SUBJECT: AMENDMENT NOS. 120 AND 123 TO FACILITY OPERATING LICENSE NOS. DPR-24  
AND DPR-27 (TACS 69349/69350)

Point Beach Nuclear Plant  
Units 1 and 2

ATTACHMENT TO LICENSE AMENDMENT NOS. 120 \* AND 123 \*\*

Figure 15.2.1-1  
REACTOR CORE SAFETY LIMITS  
POINT BEACH UNITS 1 AND 2

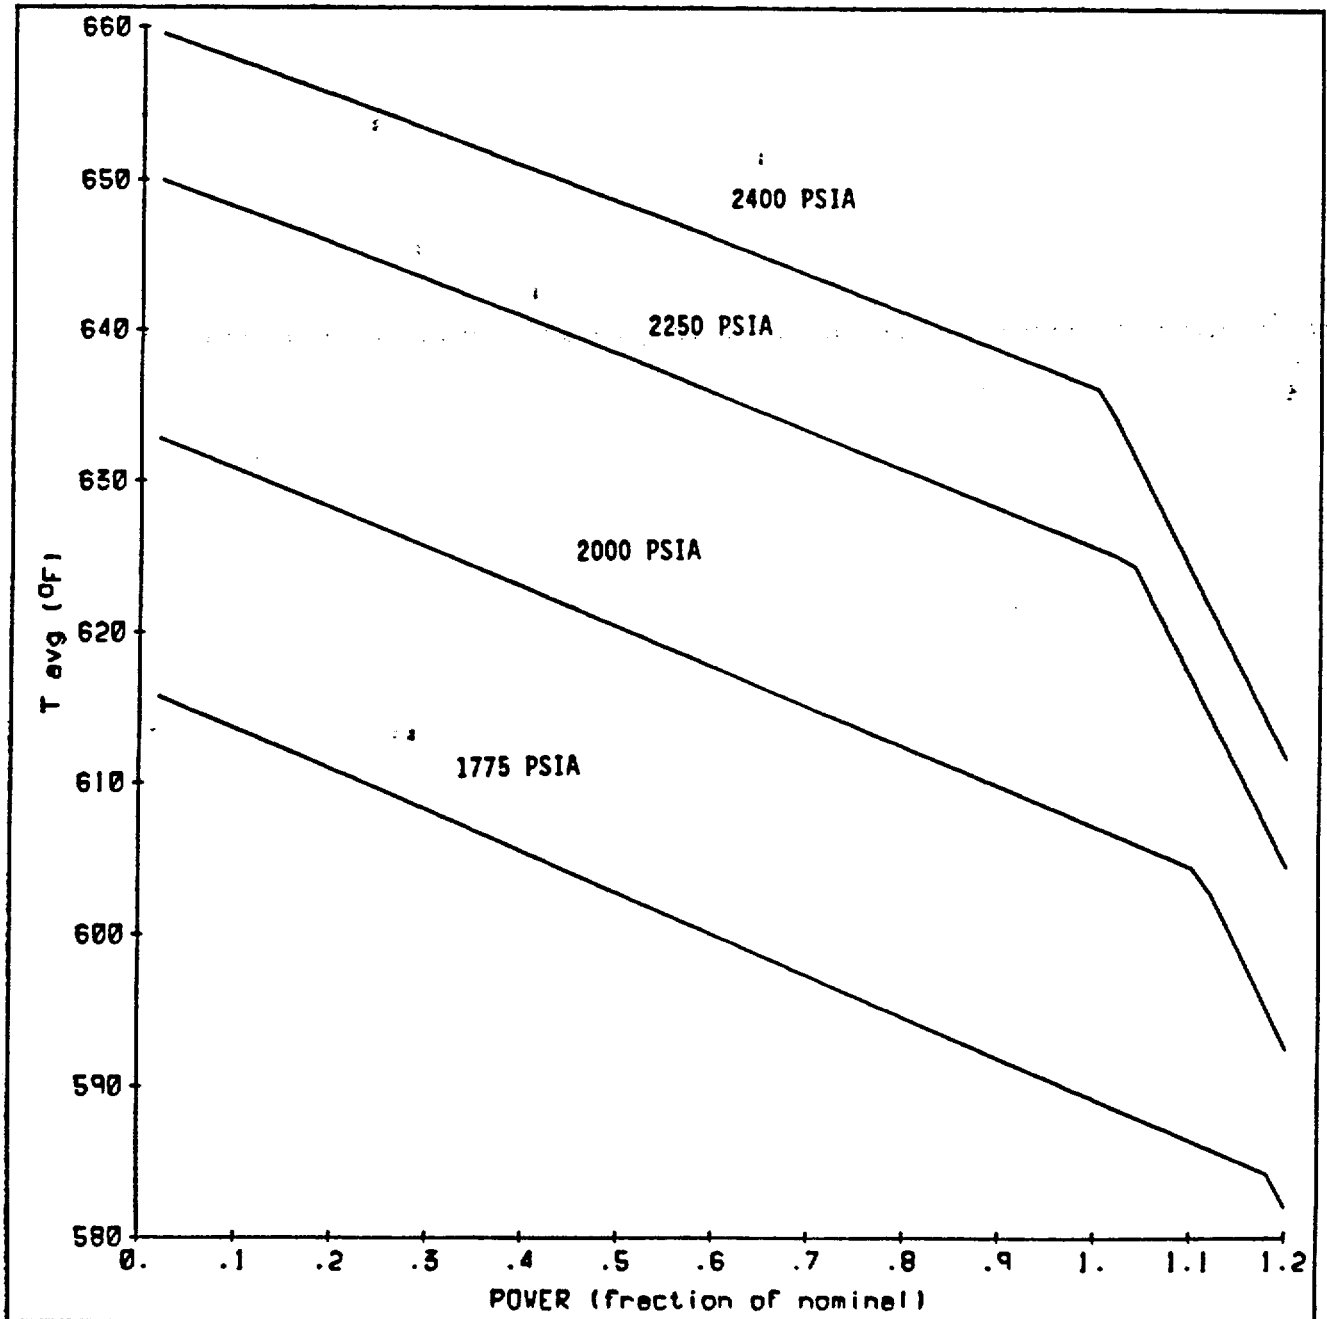
- (2) Figures 15.2.1-1 and 15.2.1-2 are replaced with a revised Figure 15.2.1-1. This is acceptable because a figure related to transition cores is removed and a new figure which corresponds to the new PBNP safety analysis is included.

FIGURE 15.3.10-1

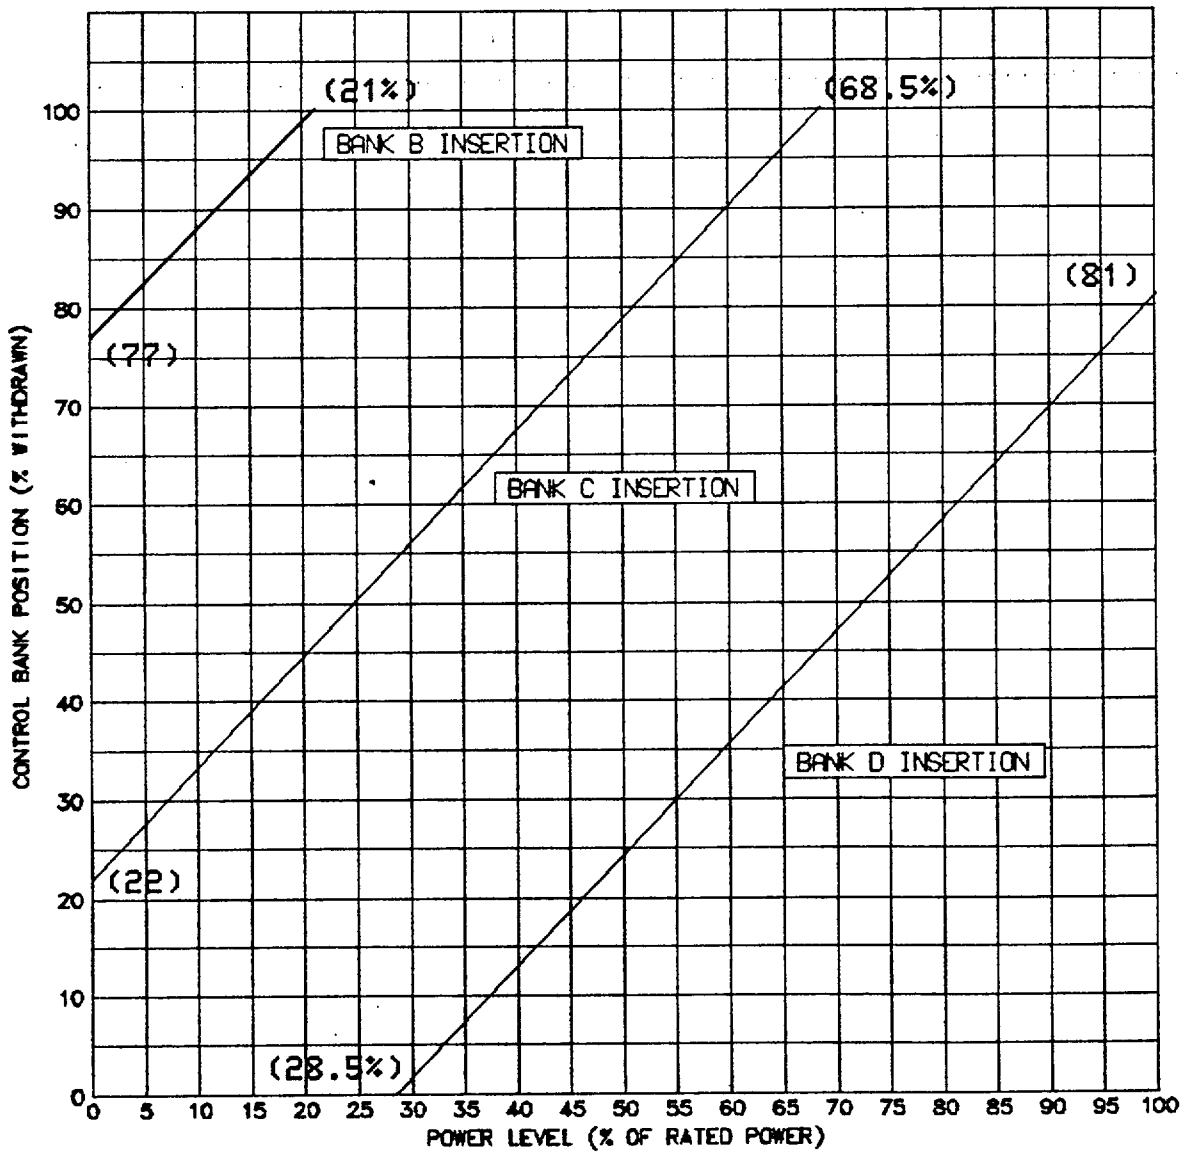
- (11) Specification 15.3.10 - Figure 15.3.10-1 on control bank insertion limits was revised to obtain a wider delta-flux band. This change is acceptable because it is used in the PBNP safety analysis.

FIGURE 15.3.10-3

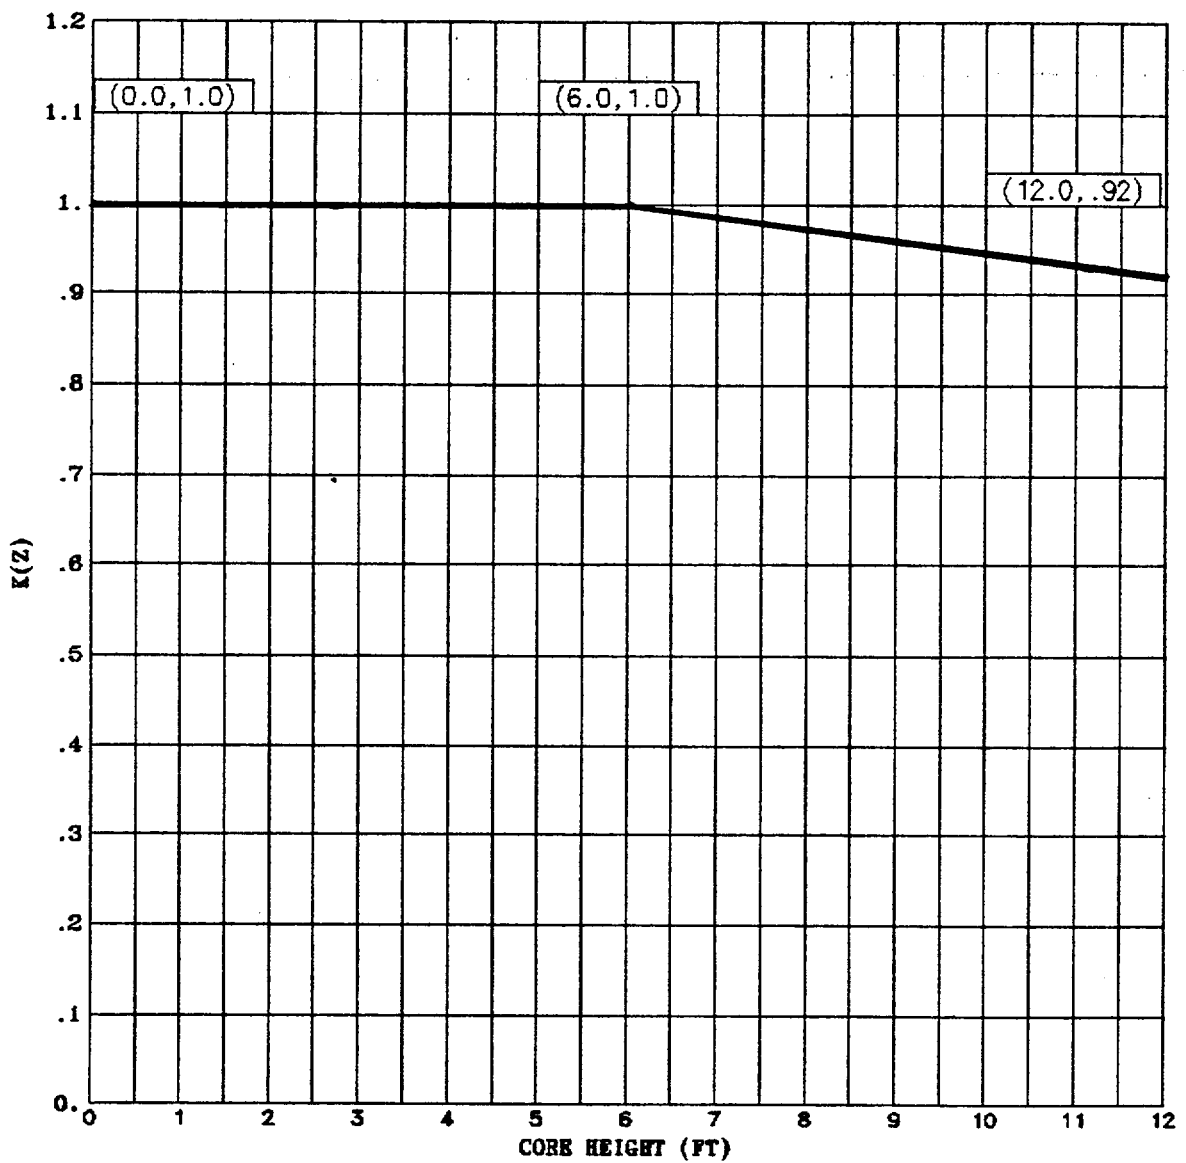
The proposed design provides for the removal of the third line segment of the Technical Specification K(Z) curve. This K(Z) curve is used to provide the required axial variation of the total peaking factor with core height such that at any core height the peaking factor limit will always be equal to or less than 2.50 (the F<sub>Q</sub> limit). The removal of the third line segment of the K(Z) curve is supported by the small-break LOCA analysis.

- (12) Specification 15.3.10 - Figure 15.3.10-3 on Hot Channel Factor Normalized Axial Operating Envelope (K(Z) curve) is revised. This revised figure is acceptable because it results in an acceptable small-break LOCA analysis as well as other safety analyses.

FIGURE 15.3.10-4

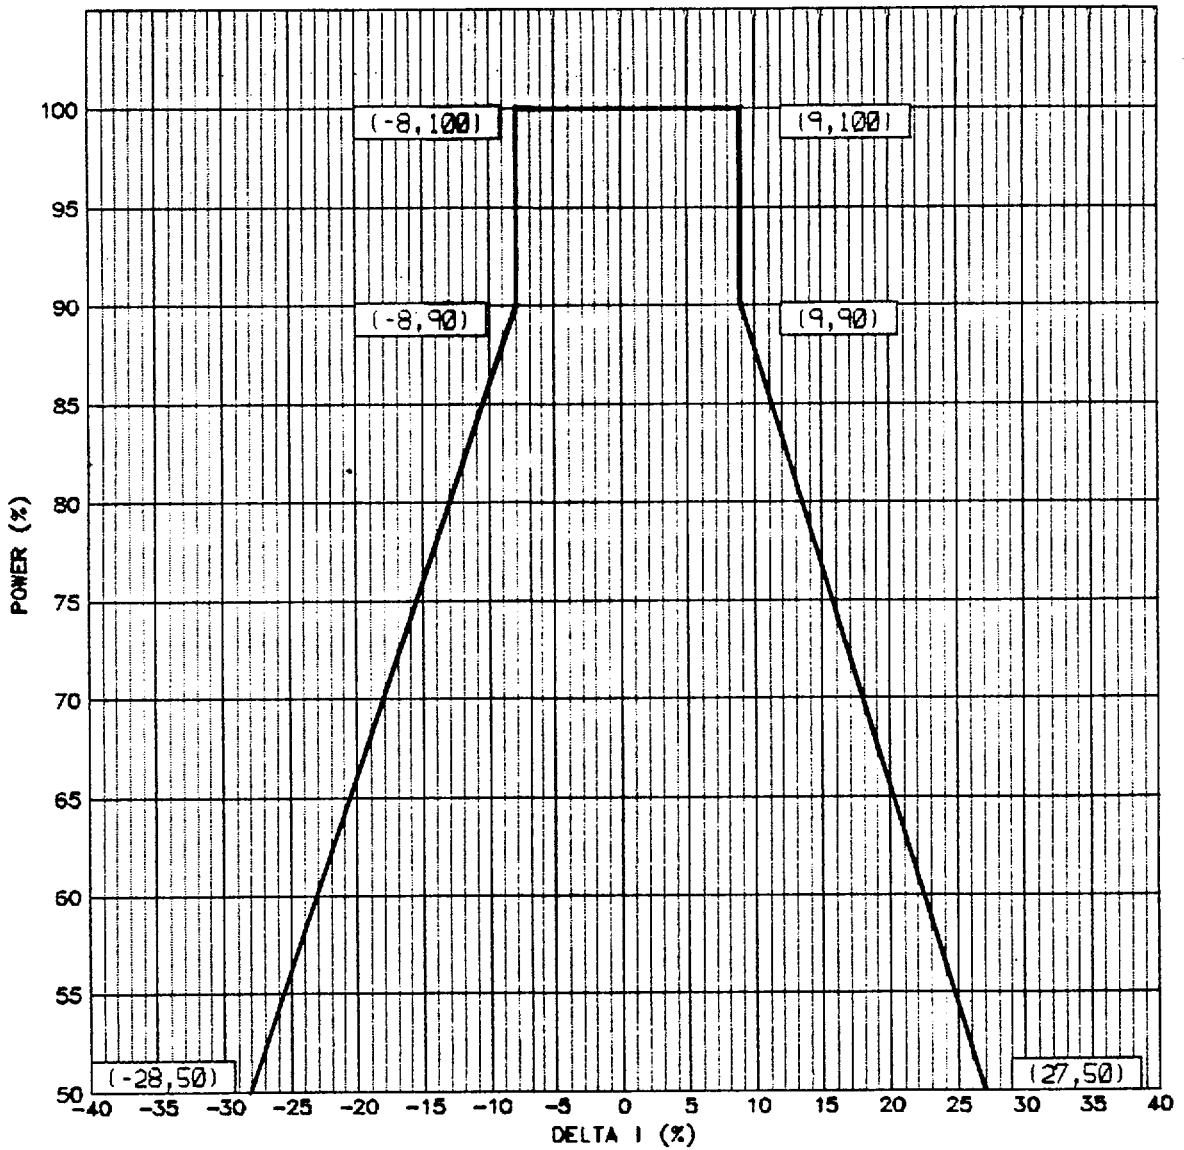
- (13) Specification 15.3.10 - Figure 15.3.10-4 on Flux Difference Operating Envelope (delta-I band) is revised. This change is acceptable because adherence to the delta-I band limits will ensure that the power distribution limits of the safety analysis will be enforced.
